ADDENDUM NO. 2

PROJECT : ***Bay District Schools
Rosenwald Building #2 Remodeling***

This Addendum #02 consists of Items 2.1 through 2.10:

DEMOLITION PLAN
ROSENWALD - FIRE MAIN EXTENSION
BAY DISTRICT SCHOOLS
 PANAMA CITY, FLORIDA

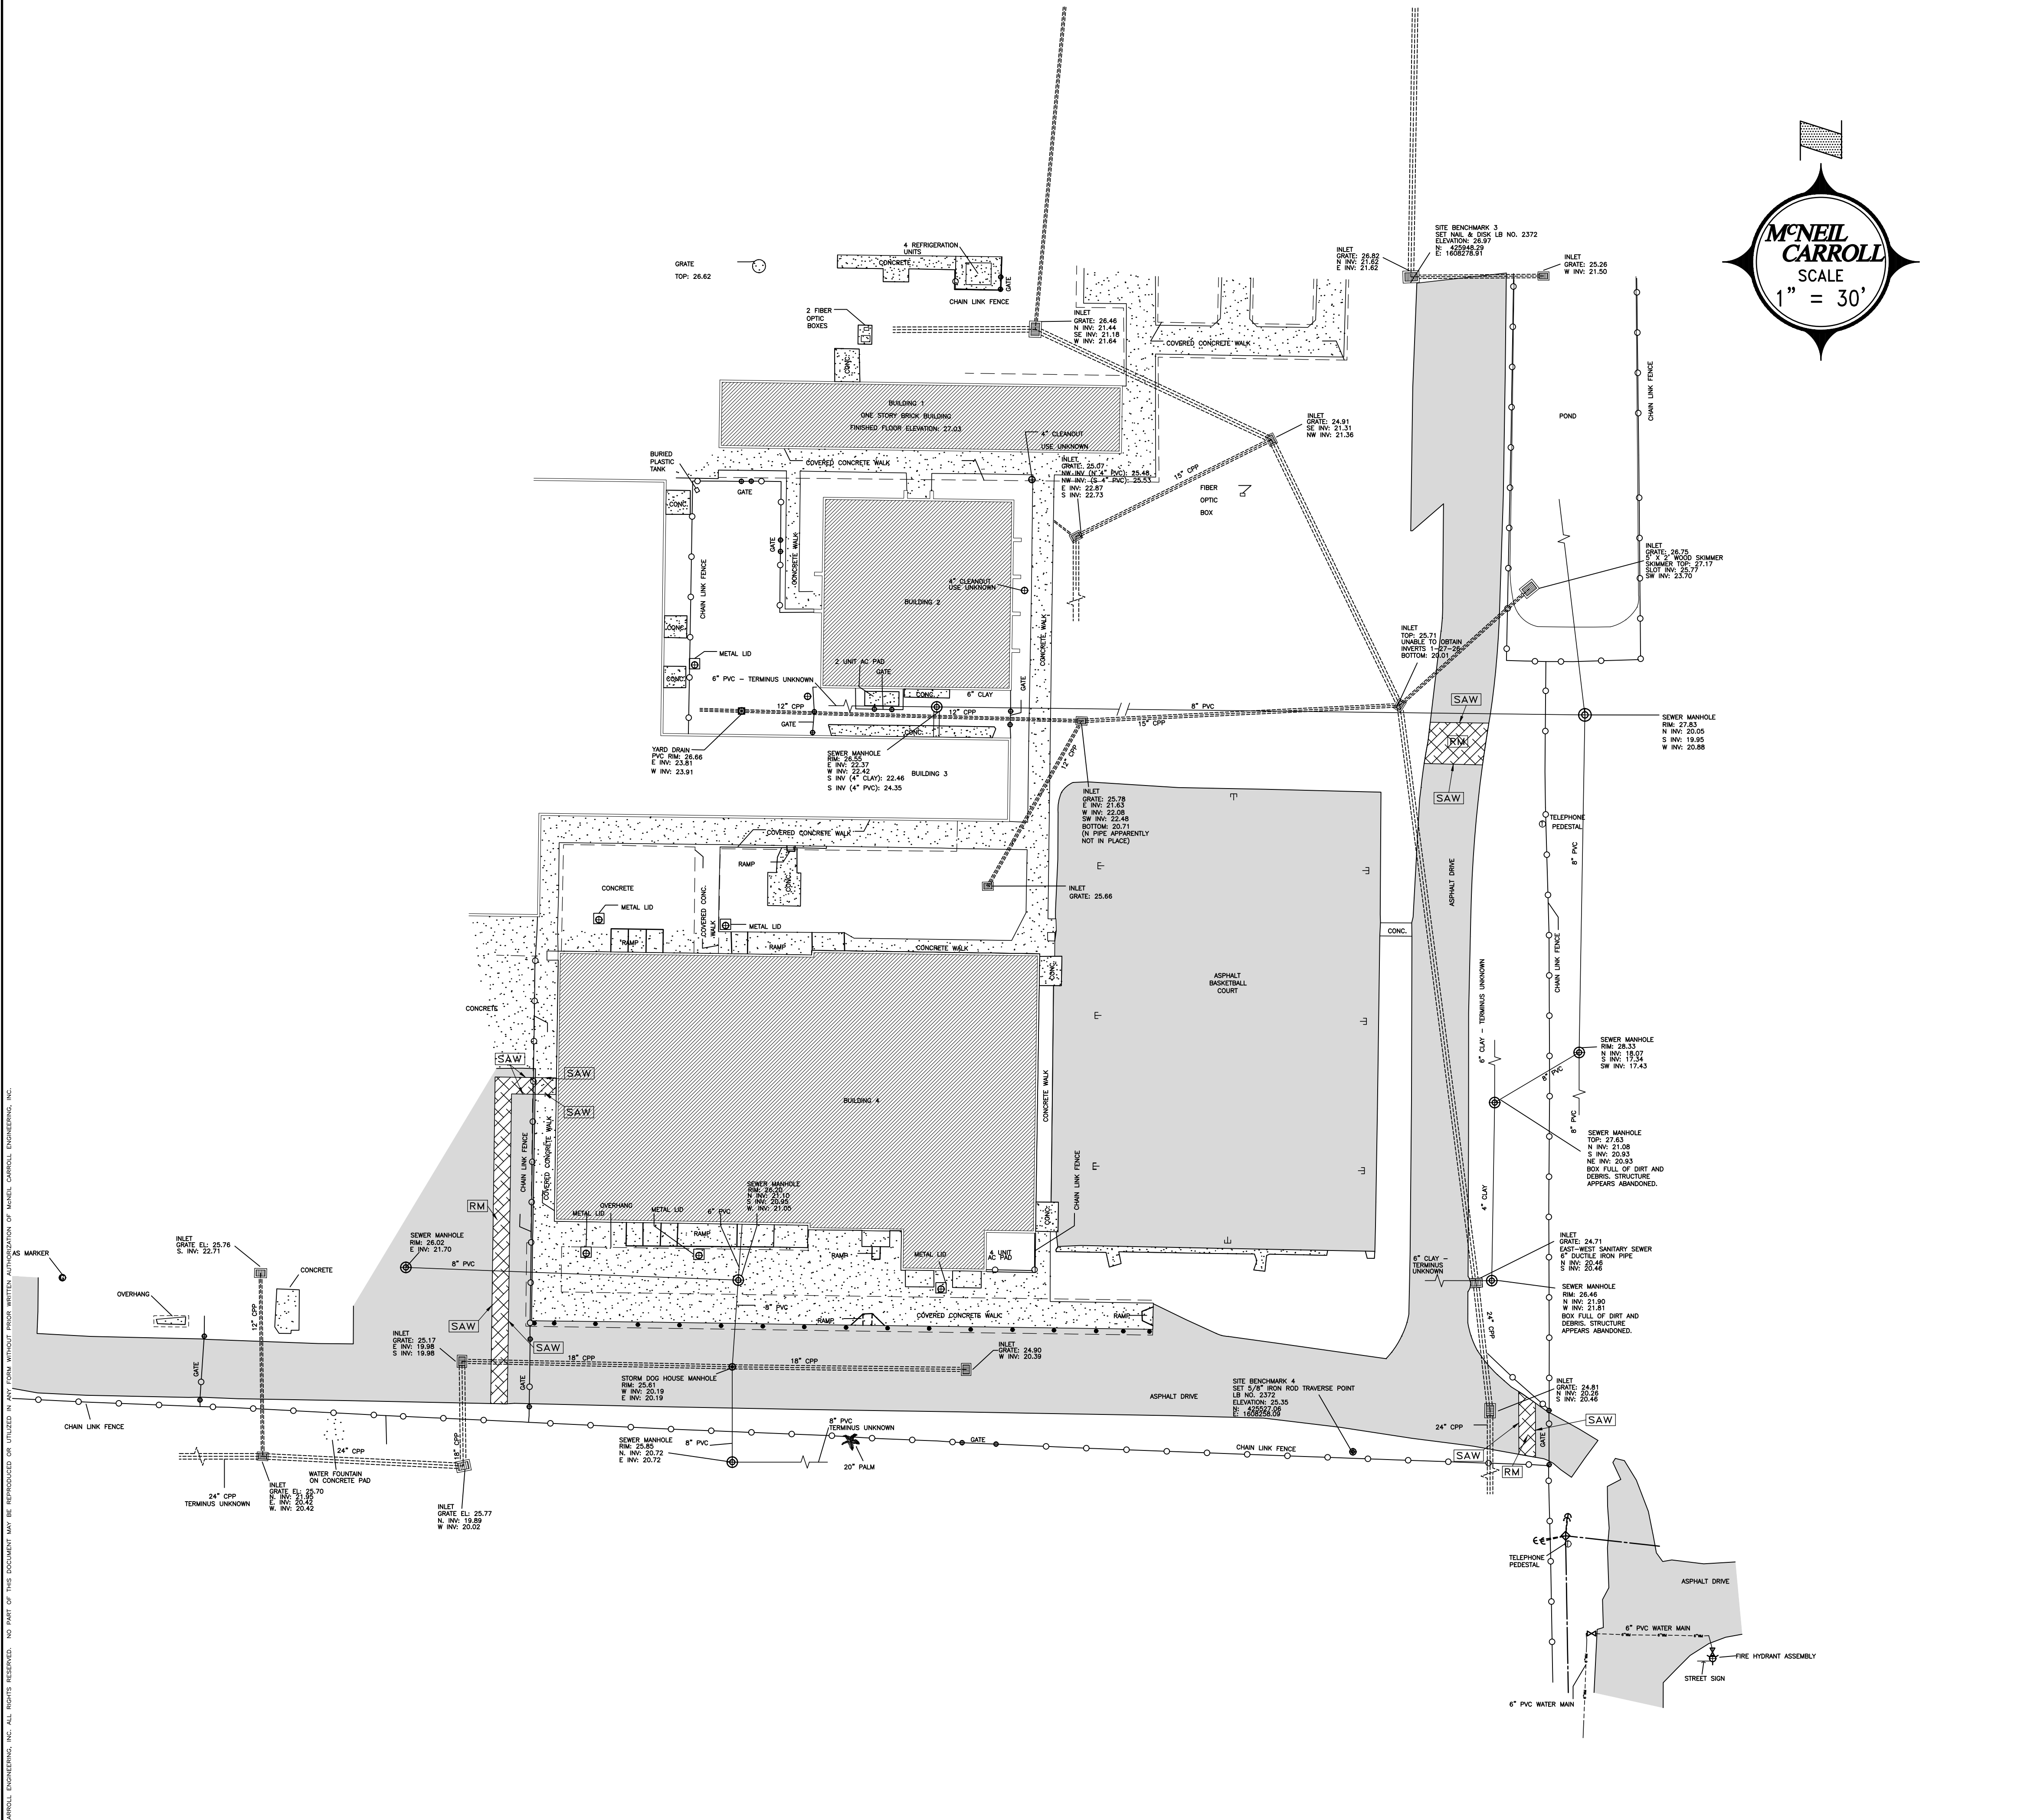
- Item 2.5 - Bid Package 02A Site Work- Updated civil drawings are being provided to show 5LF of 6" fire line with a cap and a valve for the future fire line extension.

SHEET NUMBER:
A0.1

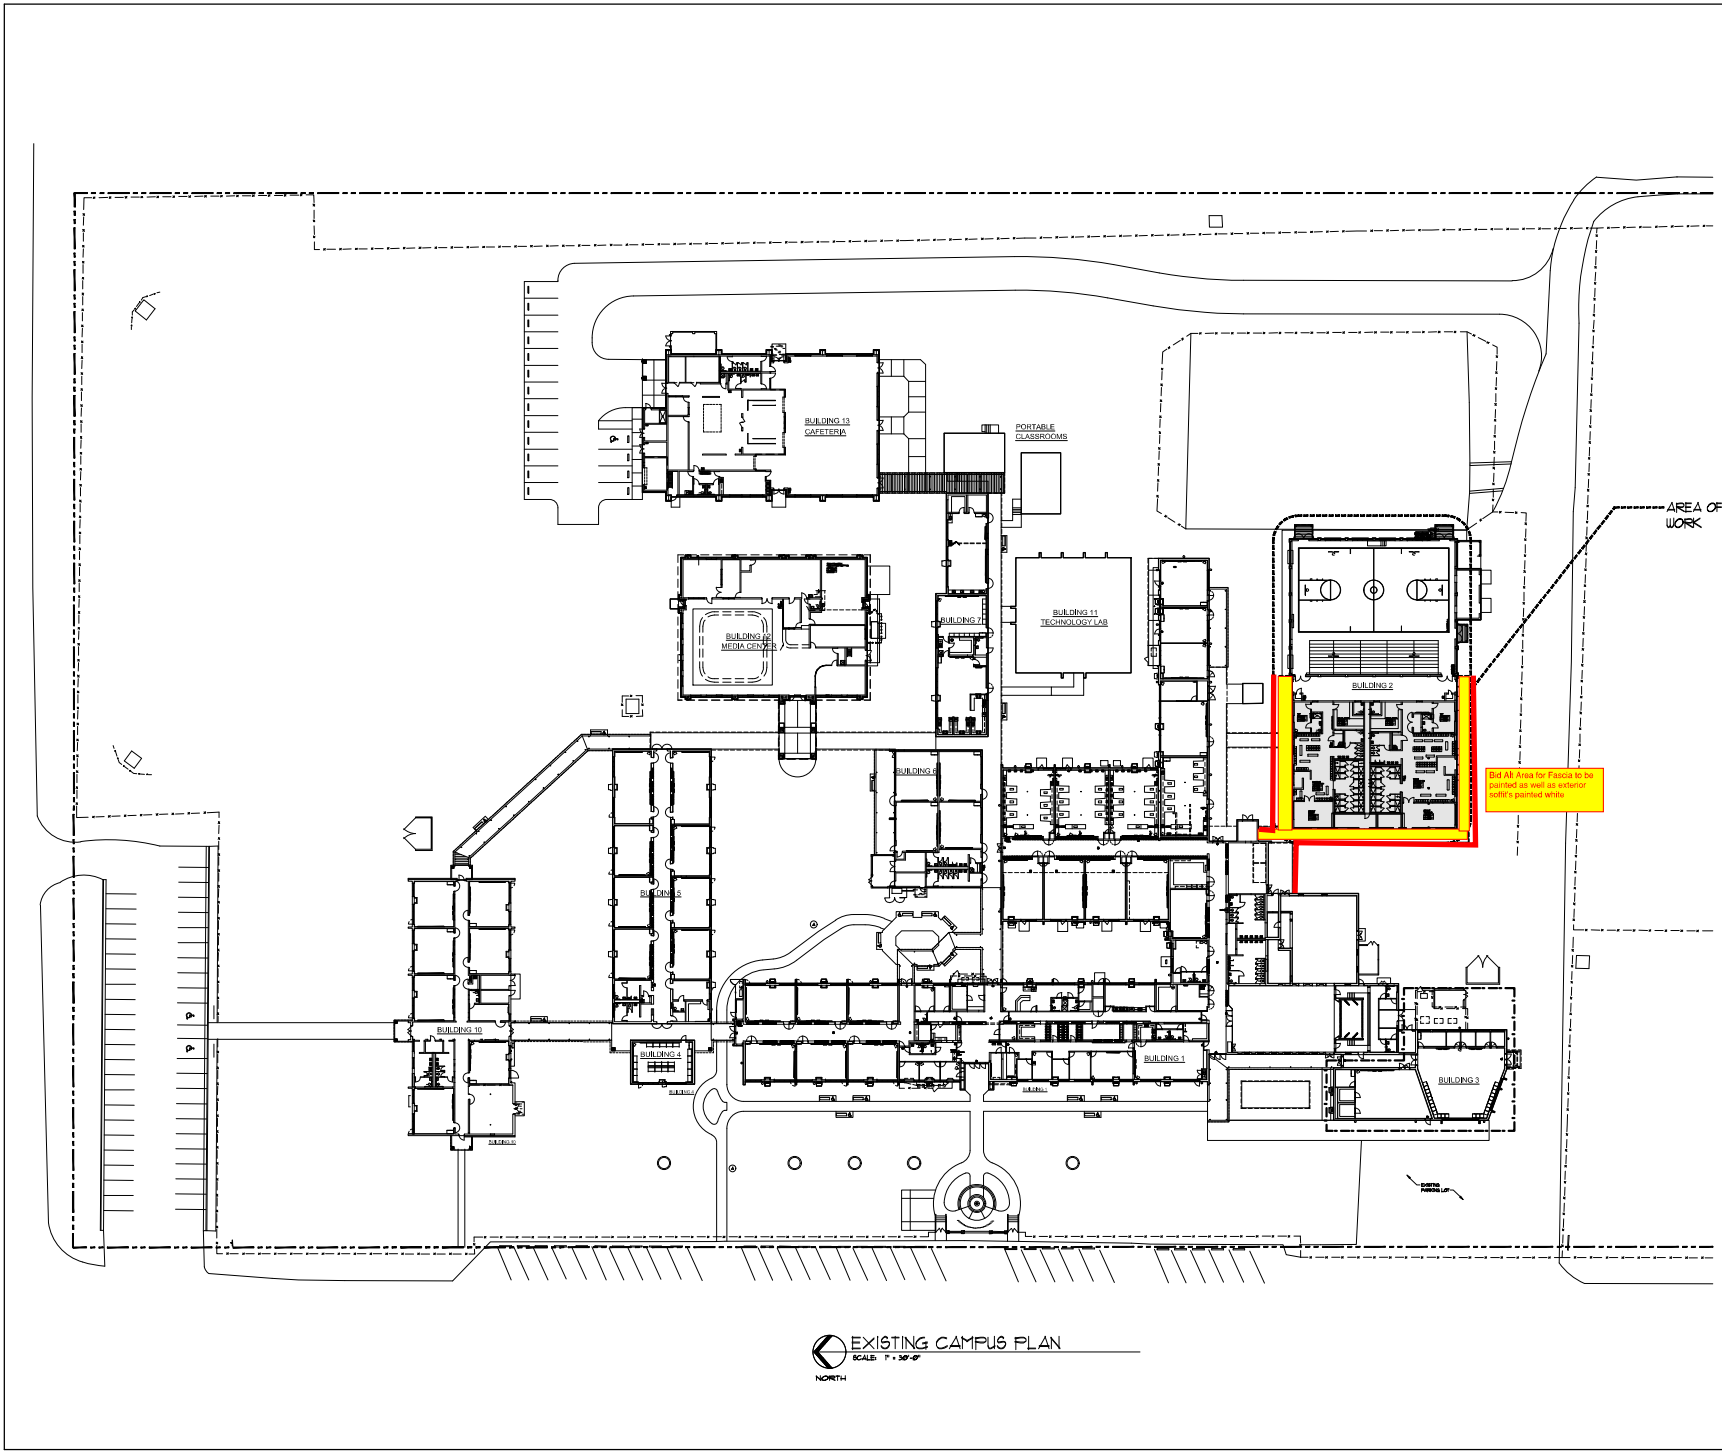
Do All Area to Facade to be painted as well as exterior roof's painted white.

- Item 2.8 - Sketch provided to show the limits of the Bid Alternate #01 Painting of existing exterior soffits and fascia.
- Item 2.9 - Bid Package 02B Demo- Added scope to remove the existing metal stud framed false wall.
